Addendum #1

Project Name: Cattle National Bank & Trust - Fallbrook
6550 Merchant Drive
Project No.: 12054
Issued: May 01, 2013
Bid Date: 2:00 pm, CDT May 14, 2013

Revision to Detail: L4.01

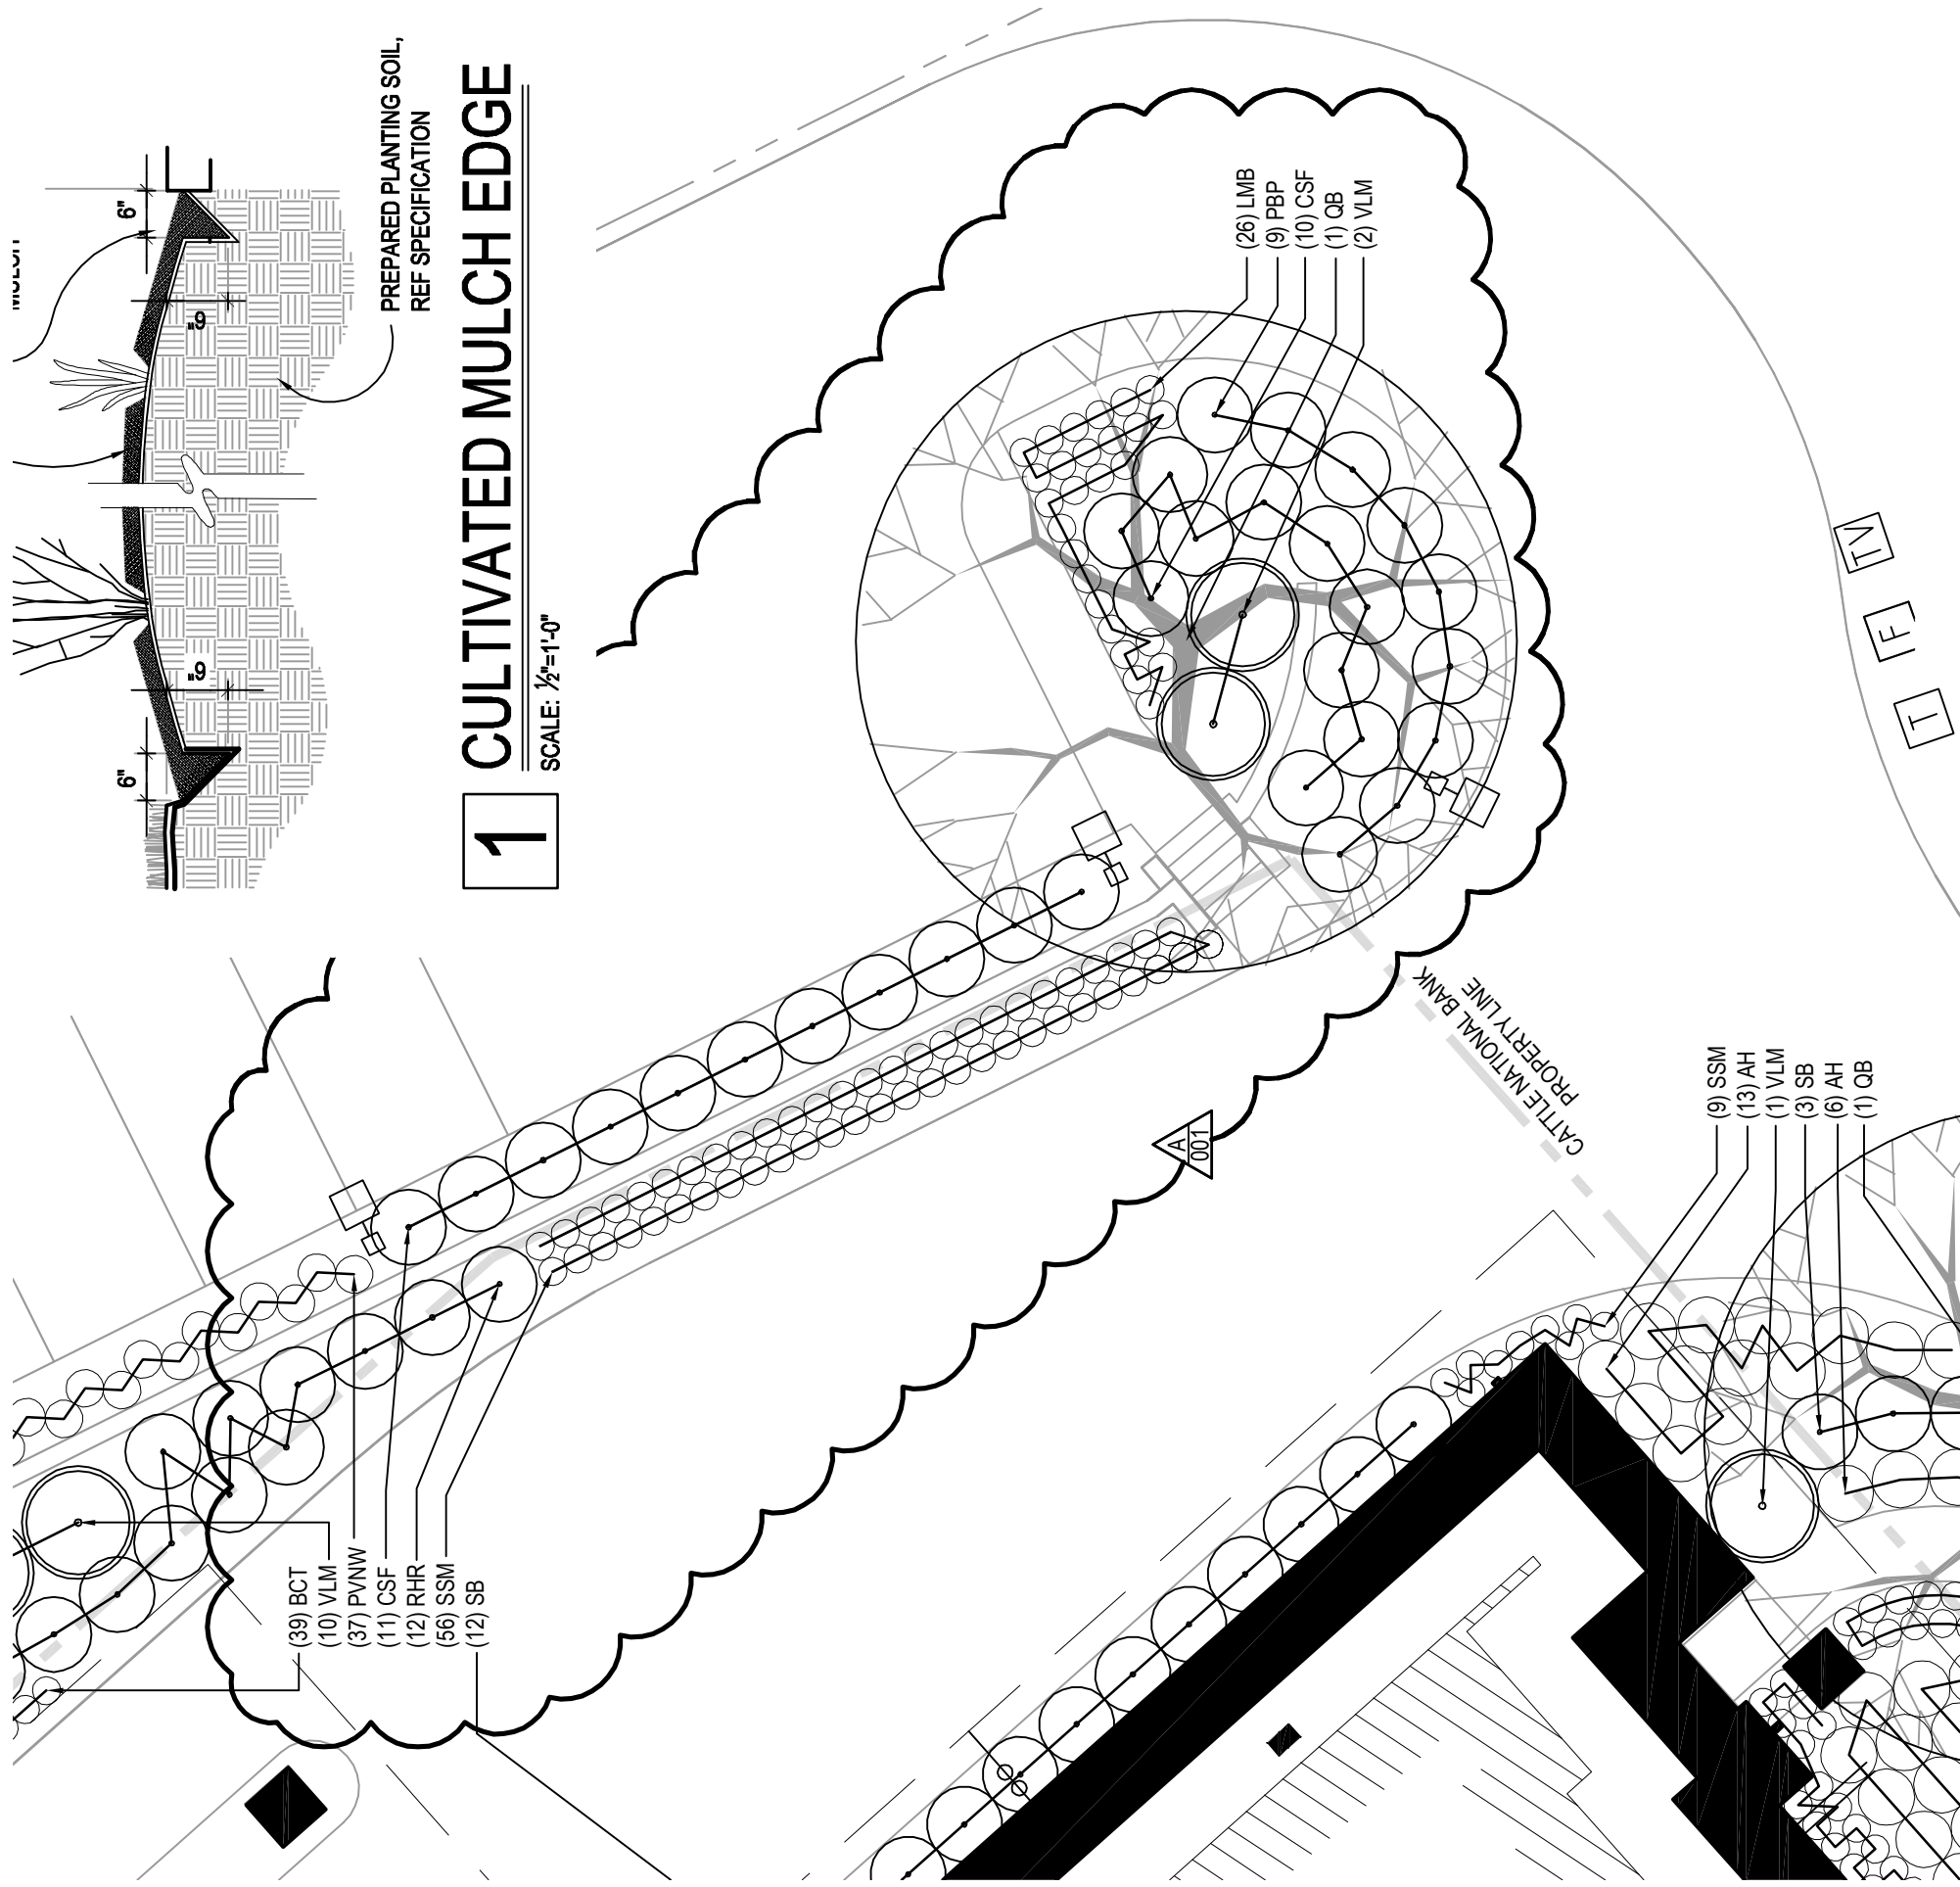
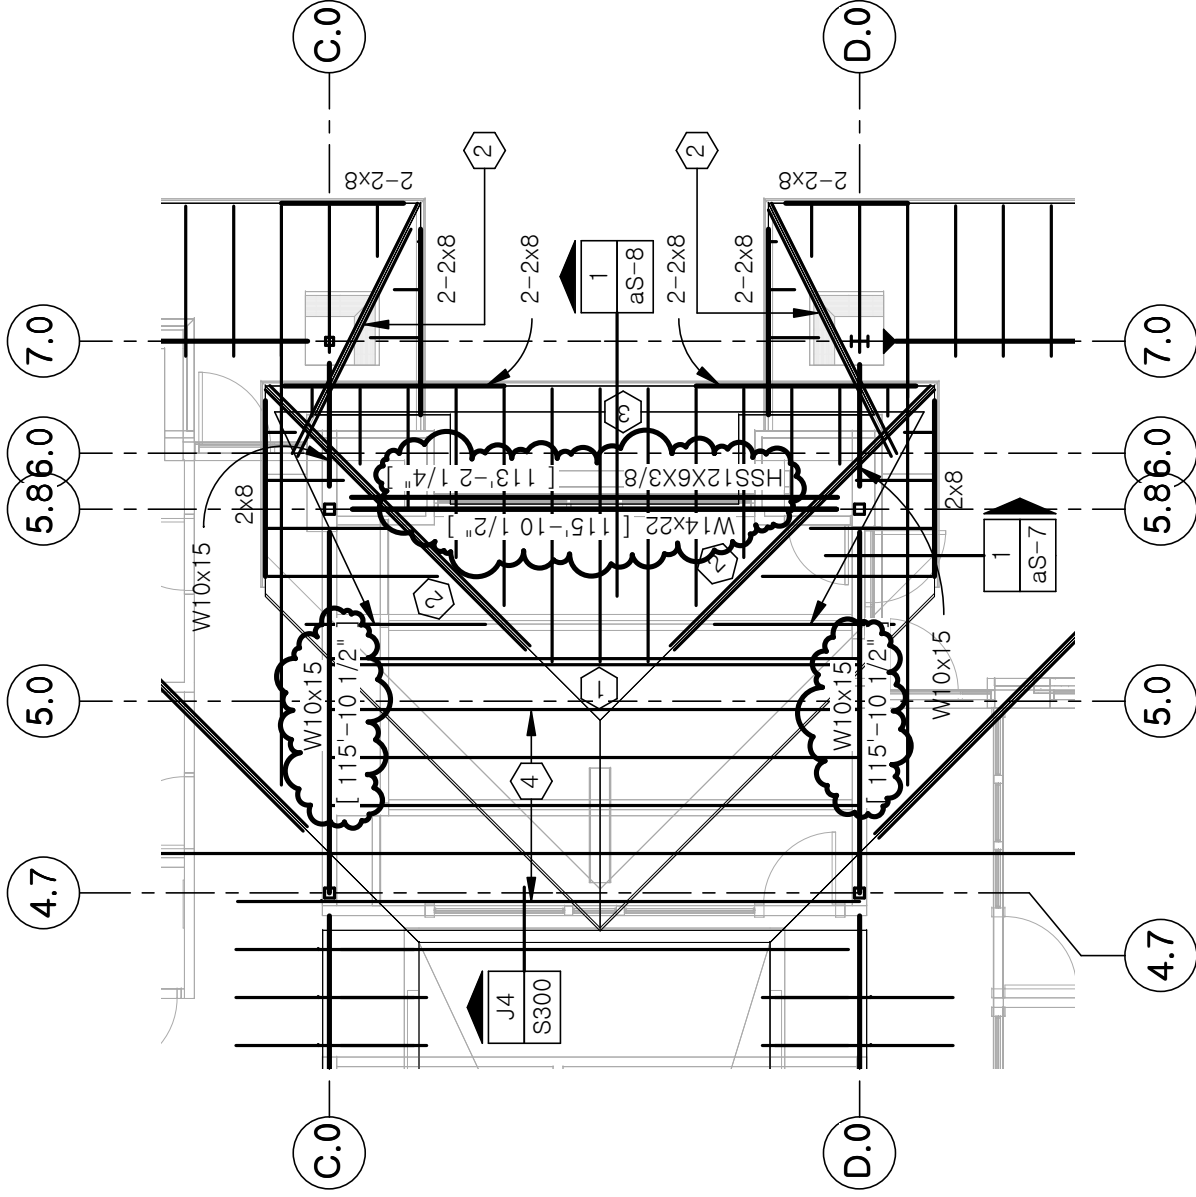
- a. Plant material was adjusted around the new walk. Refer to Attachment L01.

PARTIAL REVISED ROOF FRAMING PLAN

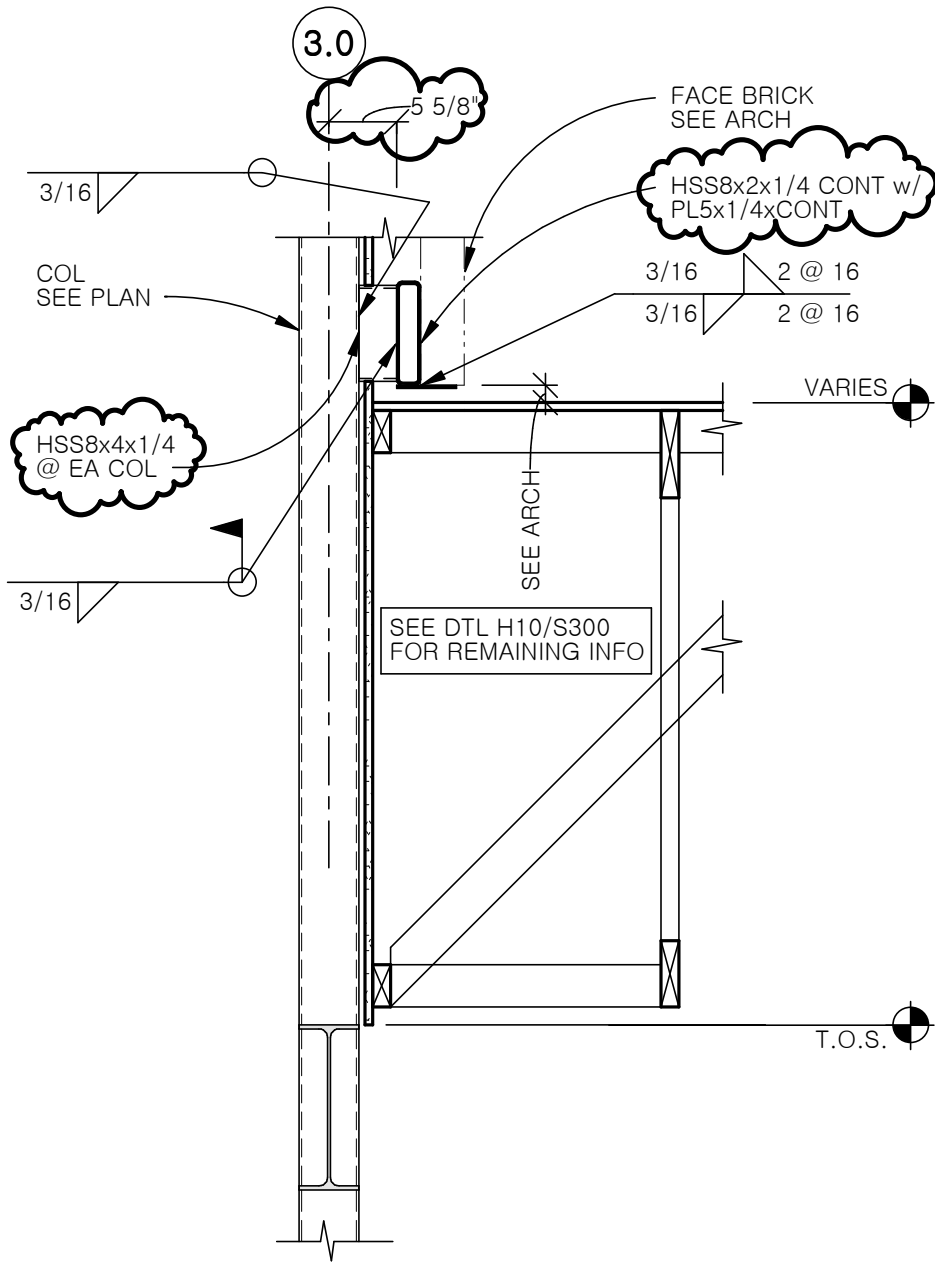
- a. Refer to sketch aS-1 for revisions to roof framing over conference room. The bottoms of the trusses and supporting steel framing have been raised.

REVISED DTL H12/S300

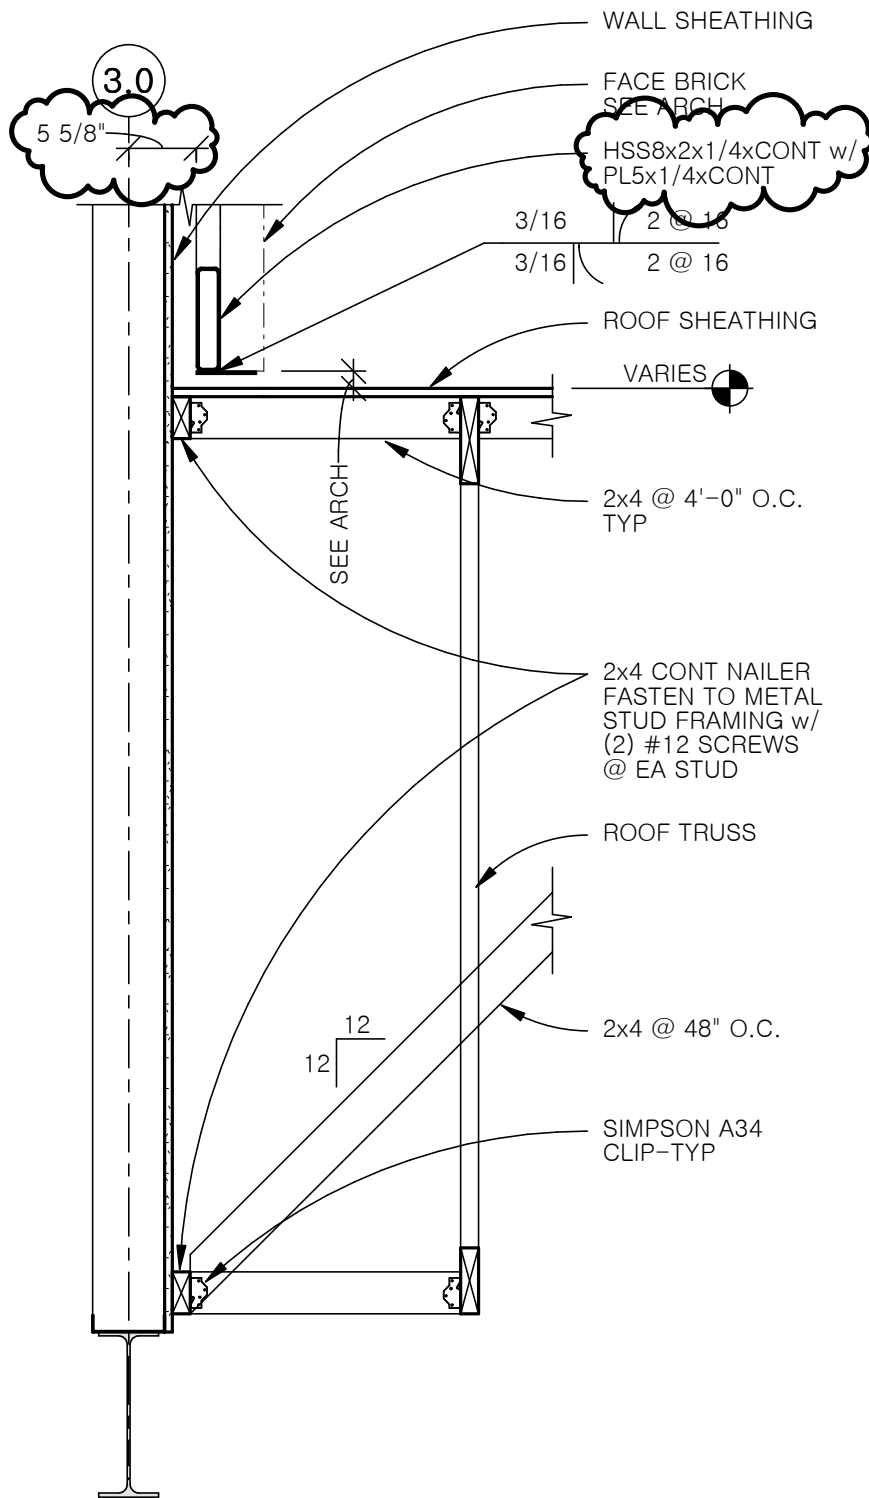
- a. The following sketches revise how face brick is supported over roof.
- b. Refer to sketch aS-2 for revised detail H12/S300.
- c. Refer to sketch aS-3 for revised detail H10/S300.
- d. Refer to sketch aS-4 for revised detail E7/S300.
- e. Refer to sketch aS-5 for revised detail J7/S300.
- f. Refer to sketch aS-6 for revised detail A7/S300.

REVISED DTL H8/S200

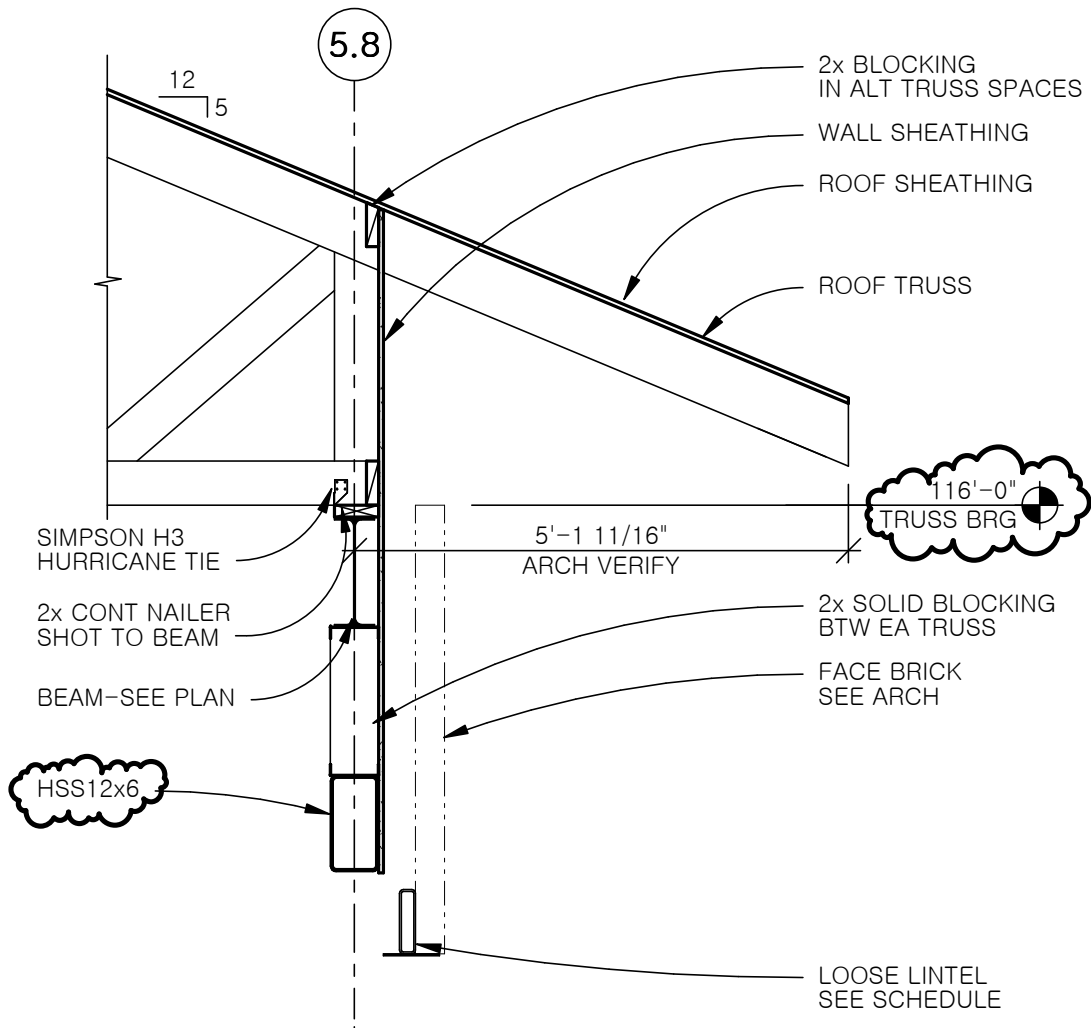
- a. Refer to sketch aS-7 for revised detail H8/S200. Top of steel beam was revised.
- b. Refer to sketch aS-9 for revised detail A5/S200. Heel height of roof truss framing has been revised.

REVISED DTL A12/S301

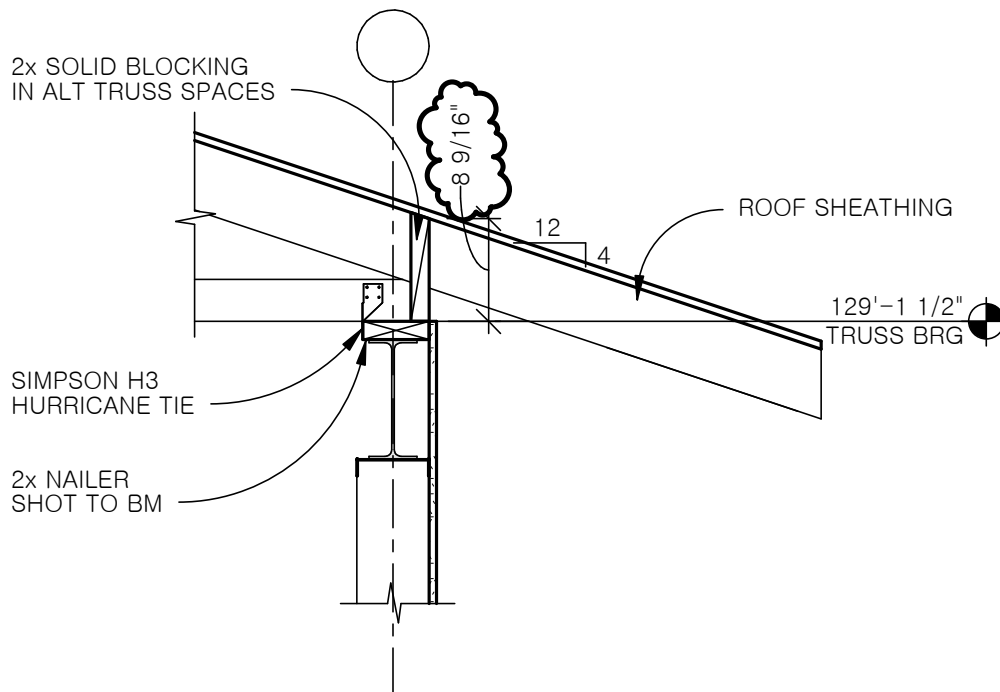
- a. Refer to sketch aS-8 for revised detail A12/S301. Truss bearing/top of steel was revised. Tube over window has been added.
